**DRAFT FINAL DECISION DOCUMENT
FOR THE INTERIM RESPONSE ACTION
AT THE
MOTOR POOL AREA
ROCKY MOUNTAIN ARSENAL
FEBRUARY 1990
CONTRACT NO. DAAA15-88-D-0022/0002
VERSION 3.1**

Re: Rocky Mountain Arsenal (RMA)
Proposed Decision Document for
the Interim Response Action at
the Motor Pool Area, November
1989.

RESPONSE TO EPA'S COMMENTS
ON THE PROPOSED DECISION DOCUMENT
FOR THE INTERIM RESPONSE ACTION
AT THE MOTOR POOL AREA, VERSION 2.0
NOVEMBER 1989

RESPONSE TO SHELL OIL'S COMMENTS
ON THE PROPOSED DECISION DOCUMENT
FOR THE INTERIM RESPONSE ACTION
AT THE MOTOR POOL AREA
VERSION 2.0, NOVEMBER 1989

**TCE SOIL GAS PLUME 1989 FIELD
INVESTIGATION MOTOR POOL AREA**

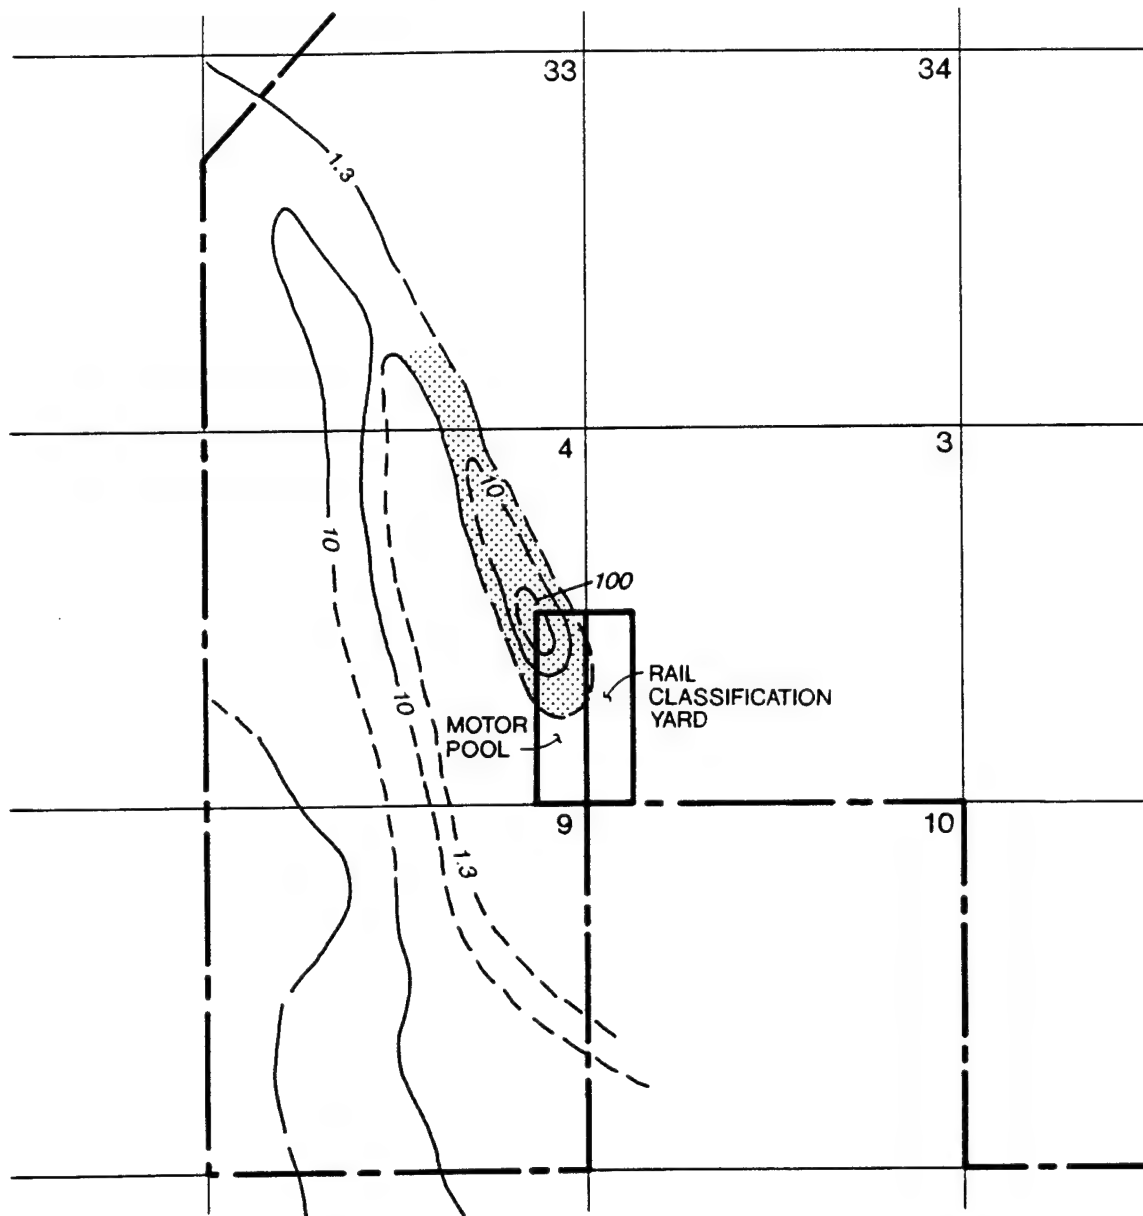
Comment 2: Units of concentration from the soil gas survey should be applied to the concentration lines on Figure 2-3.

Comment 7: In Figure 2-3, the soil gas concentration contours do have units. If the units are ug/l gas, then there appears to be an approximate order of magnitude discrepancy between values reported in this study and the Ebasco investigation (see Figures 2-17, results of field and laboratory investigations conducted for the remediation of other contamination sources).

Response: The figure has been revised.

Response: Soil gas is a fairly qualitative method of identifying possible sources of contamination. Both investigations indicate a contamination source in the same vicinity. However, soil contamination concentrations cannot be quantitatively inferred from soil gas results.
